**Economic and Social Council**Distr.: General  
17 February 2014

**Economic Commission for Europe****Inland Transport Committee****World Forum for Harmonization of Vehicle Regulations****Working Party on General Safety Provisions****106<sup>th</sup> session**

**Regulation No. 107 (M<sub>2</sub> and M<sub>3</sub> vehicles) –****Requirements for service doors, windows and emergency exits****Proposal for amendments to Regulation No. 107 (M<sub>2</sub> and M<sub>3</sub> vehicles)****Submitted by the expert from Hungary<sup>\*</sup>**

The text reproduced below was prepared by the expert from Hungary to propose amendments to the provisions on the access to escape hatches. It is based on informal document GRSG-105-05 and supersedes ECE/TRANS/WP.29/GRSG/2013/17 (see report ECE/TRANS/WP.29/GRSG/84, para. 15). The modifications to the current text of UN Regulation No. 107 are marked in bold for new or strikethrough for deleted characters.

"Figure 26

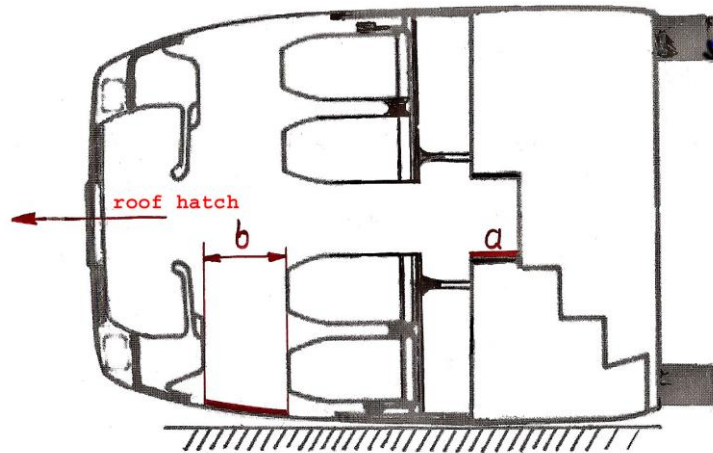
"7.7.4.1. Access to escape hatches, **when the vehicle is lying on either side**

**Free motion of the passengers shall be assured along the internal wall of the vehicle to reach the roof hatches. This requirement is met if at least one of the following two requirements is fulfilled (see Figure 26 in Annex 4):**

7.7.4.1.1. **There is a sunken gangway having a minimum vertical distance "a" between the gangway surface and the floor of the seating area of [150] mm, or**

7.7.4.1.2. **There is a free height "b" of not less than [400] mm measured from the highest point of each seatback."**

Annex 4, Figure 26, replace the existing figure as follows:

Figure 1  
Sketch

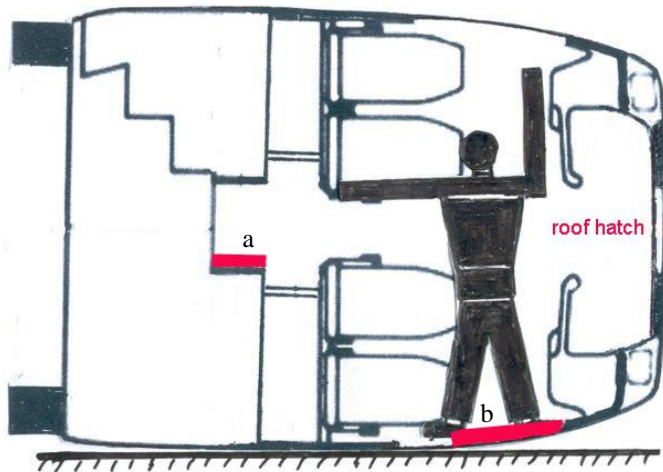
2. Figure 1 below shows two almost horizontal surfaces for the passenger's motion ("a" in the gangway and "b" on the side walls)

3. The gangway cannot be used automatically if there is no horizontal surface, on which the passengers can place their feet and move. A sunken gangway is needed.
4. A better way is the horizontal "b" surface on the side wall.
5. Some photos from real accidents help to illustrate this situation, including the escape or rescue of the passengers (see Figures 2.1 to 2.4).
6. The situation could be worse if passengers using seat belt are hanging on the belt, or passengers without seat belts fell onto each other
